**STAFF REPORT
TOWN COUNCIL MEETING OF AUGUST 12, 2014
BUSINESS ITEM**

RE: CALTRANS ENCROACHMENT PERMIT FOR THE HORSESHOE BAR BRIDGE METAL ARTWORK AND TREE PLANTING PROJECTS.

0314-NLF0423

0314-NGM0424

PP-2

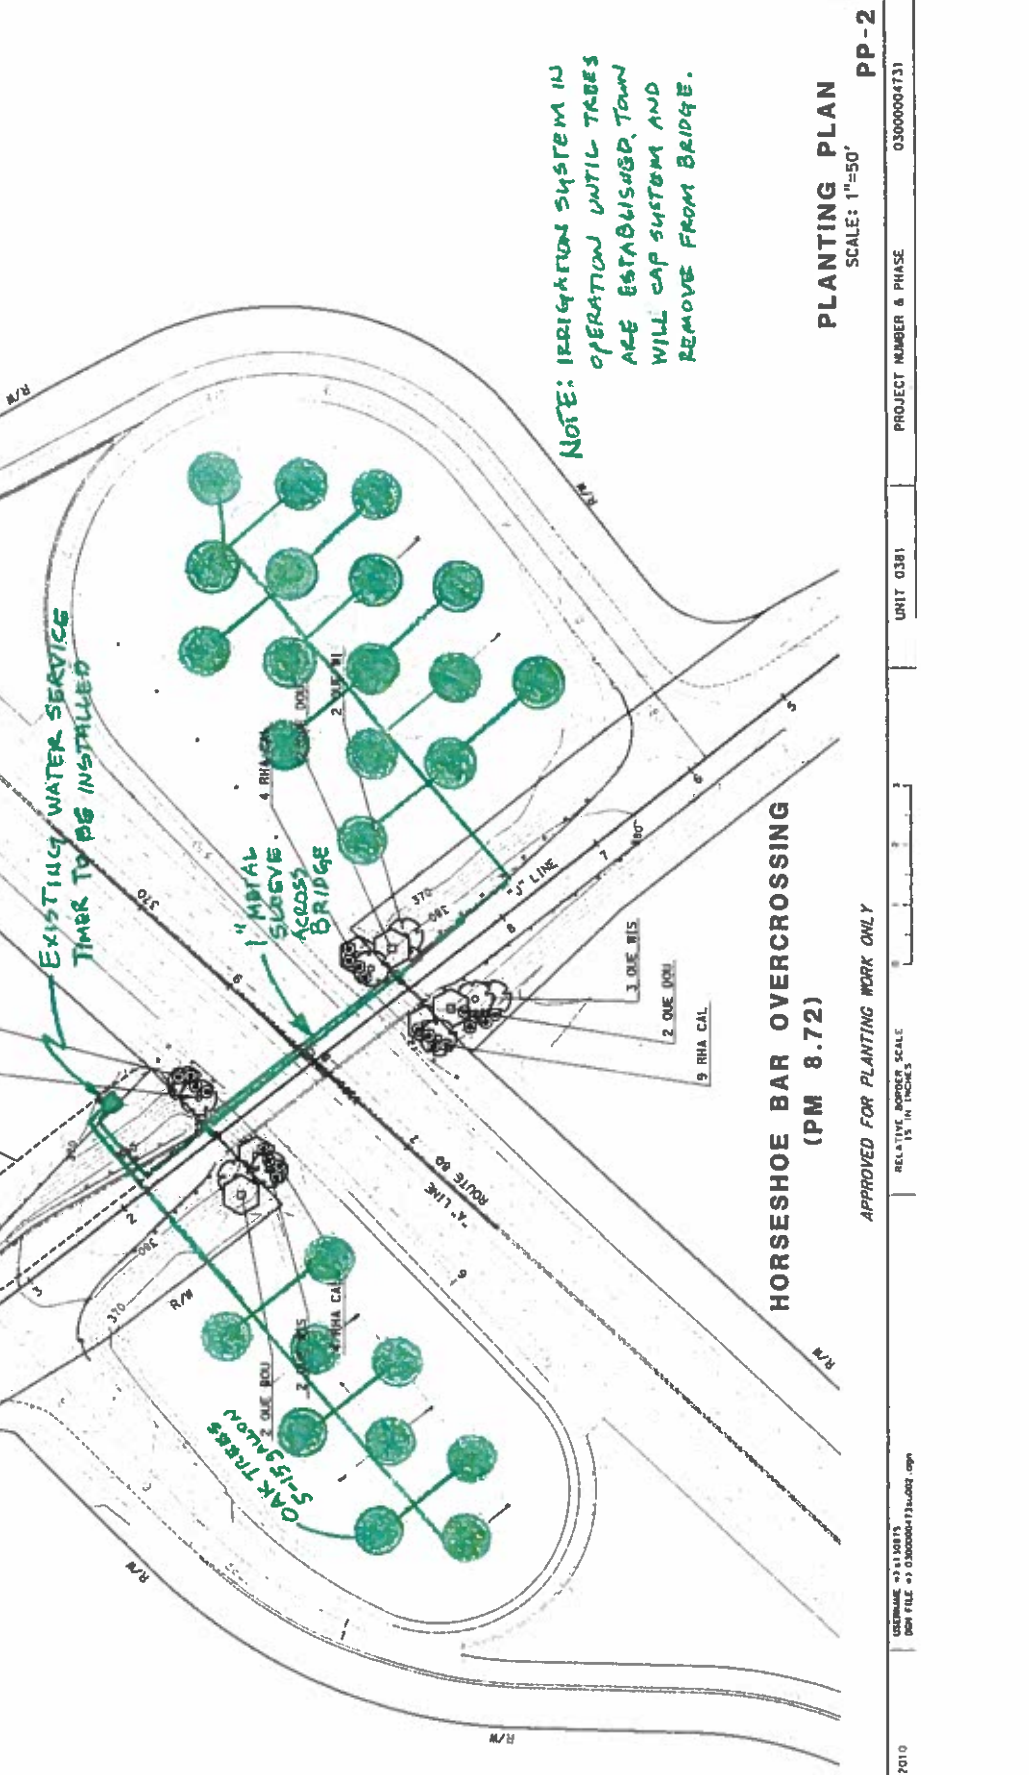
1. Do not use the Landscape Architect licensed seal for James C. Williamson on your plans. He is NOT authorized to do this work under his license.
2. On plans, list the botanical and common names of plants that are being proposed. Show a legend for plant and irrigation symbols. List what type of irrigation heads are proposed.
3. Provide individual plant basins covered with 3 inches of mulch. Mass-mulching is acceptable also.
4. Check setback requirements for plant placement.
5. How is schedule 40 irrigation pipe to be placed under Horseshoe Bar?
6. Who owns the existing water meter and who is paying for the water?

1. Please add bridge number to plan sheet.
2. Provide duration of irrigation system in operation until trees are established.
3. Review Bridge (#19-0097) General Plan for alternative location of temporary irrigation line.

NOTE: IRRIGATION SYSTEM IN OPERATION UNTIL TREES ARE ESTABLISHED. TOWN WILL CAP SYSTEM AND REMOVE FROM BRIDGE.

HORSESHOE BAR BRIDGE ART WORK

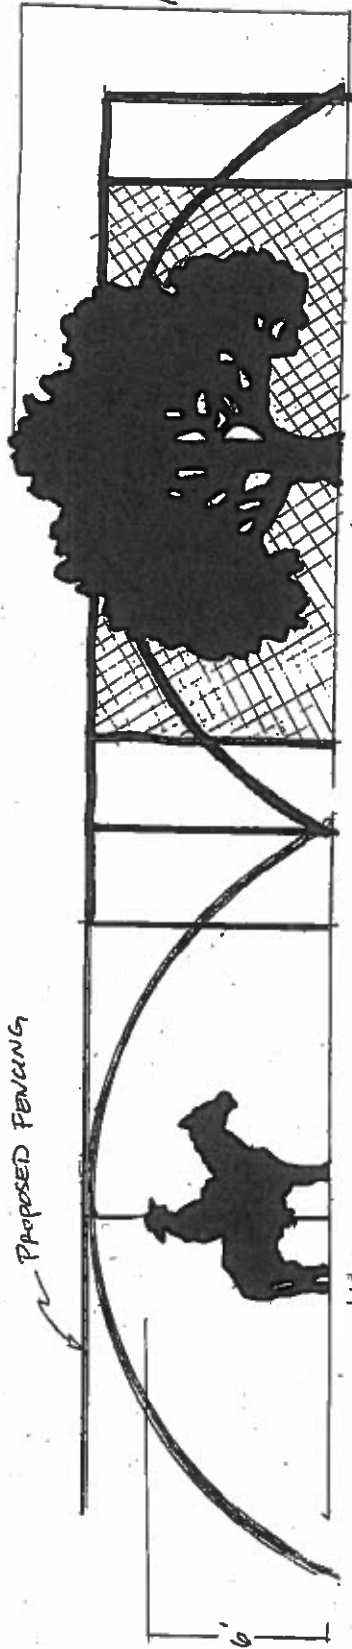
1. Please add bridge number to the plan sheet.
2. Provide engineering calculations due to weight of art work and wind load increases to the structure.
3. Structural analyses of applied wind load on the art work need to be determined by the City or County. When the City or County is unable to determine design wind speed, the basic wind speed shall not be less than 100 mph.
4. Provide a plan sheet showing the details of art work connections to pedestrian fence line.
5. The plans and engineering calculations shall be stamped and signed by a California Registered Engineer.
6. Concrete anchor reinforcement must be located by nondestructive means before installing holes for anchors. Rotary drills to be used, no impact drills or coring. If reinforcement is encountered the anchor hole shall be abandoned, patched and a new hole installed. Anchor must be on Caltrans Authorized

7. All anchorage to concrete shall be detailed using Concrete Anchorage Devices from the Caltrans approved products (http://www.dot.ca.gov/hq/esc/approved_products_list/).

You are showing an example of art work in a roundabout on Rocklin Road, What are you proposing for this project? The location, and size and materials are important to evaluate.
